## Green Star – Office Interiors v1.1

### Indoor Environment Quality IEQ-14 Tenant Exhaust

##### IEQ-14 'Tenant Exhaust'

**GBCA Fit-Out**  
**CIR – IEQ 14: Tenant Exhaust**  
11/06/2008  
ADV0702600

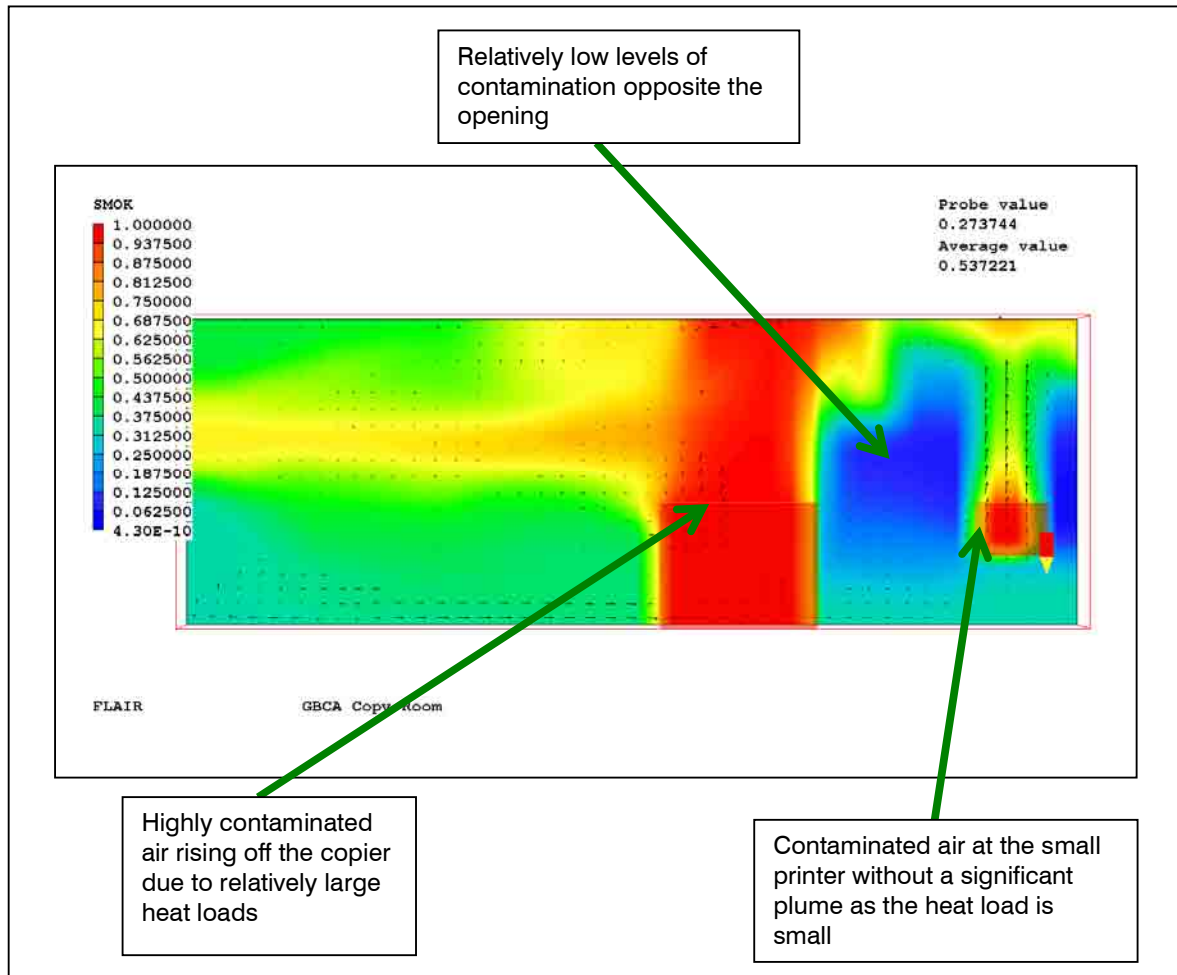
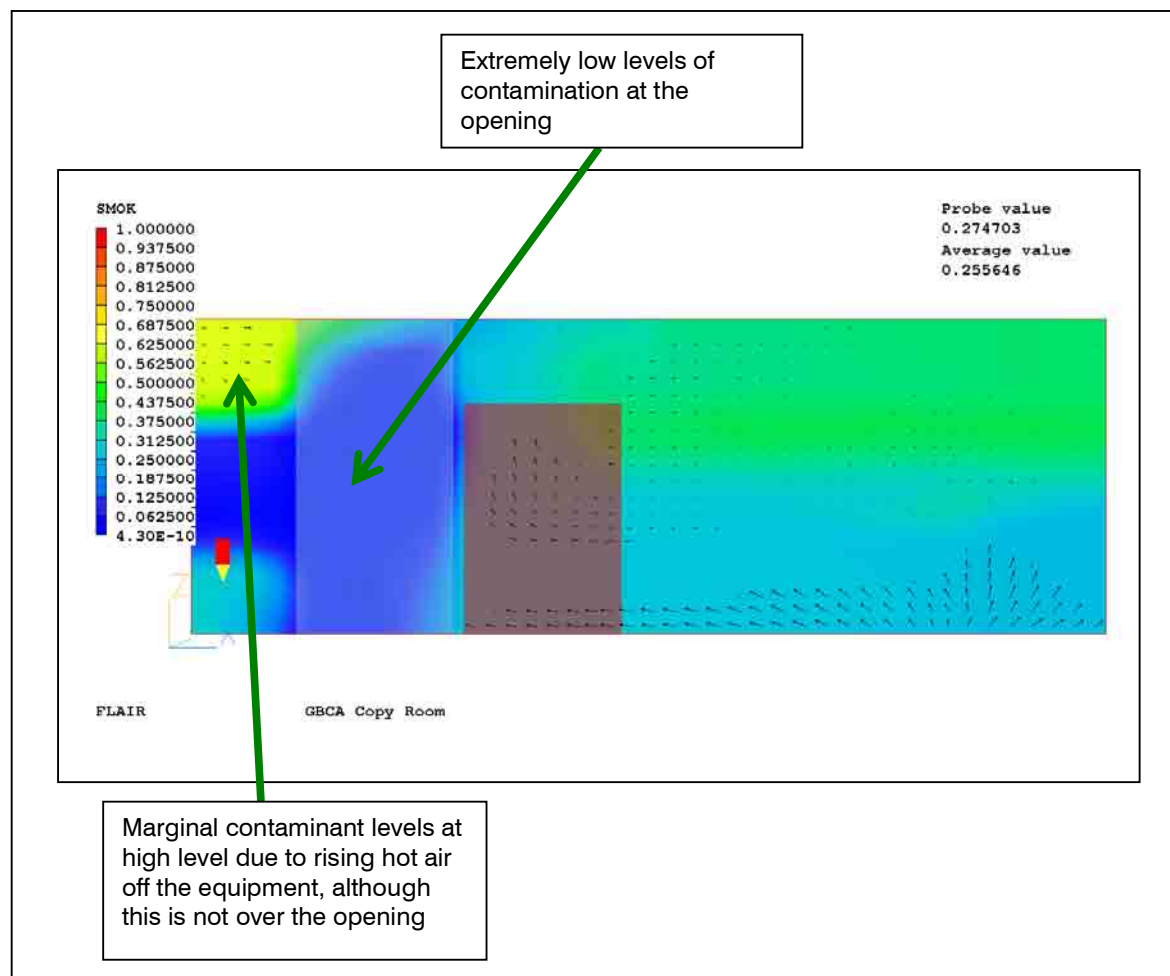
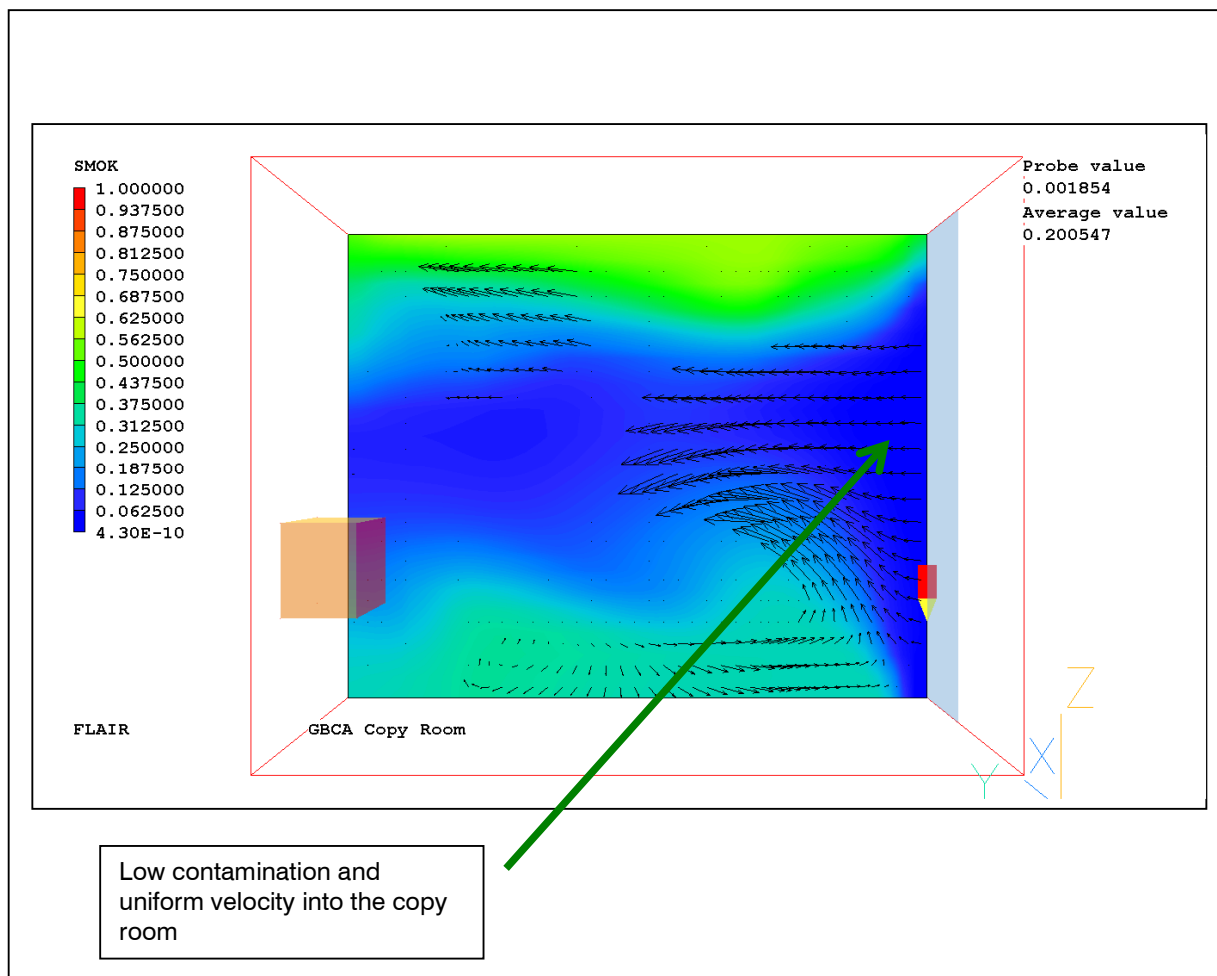
CIR Ruling: The Credit Interpretation Request (CIR) to have a negatively pressured moderately enclosed room (i.e. a room which is contained by three or more walls, and has an opening that is larger than 1.2 x 2. metres) that is being exhausted per the Technical Manual as shown by a Computational Fluid Dynamics (CFD) model be deemed equivalent to an enclosed room is granted.

Please note: This CIR approves the use of CFD modeling to show that a negatively pressured moderately enclosed room can be exhausted as per the Credit Criteria and Compliance Requirements on the Technical Manual. It does not automatically grant the points for this credit.
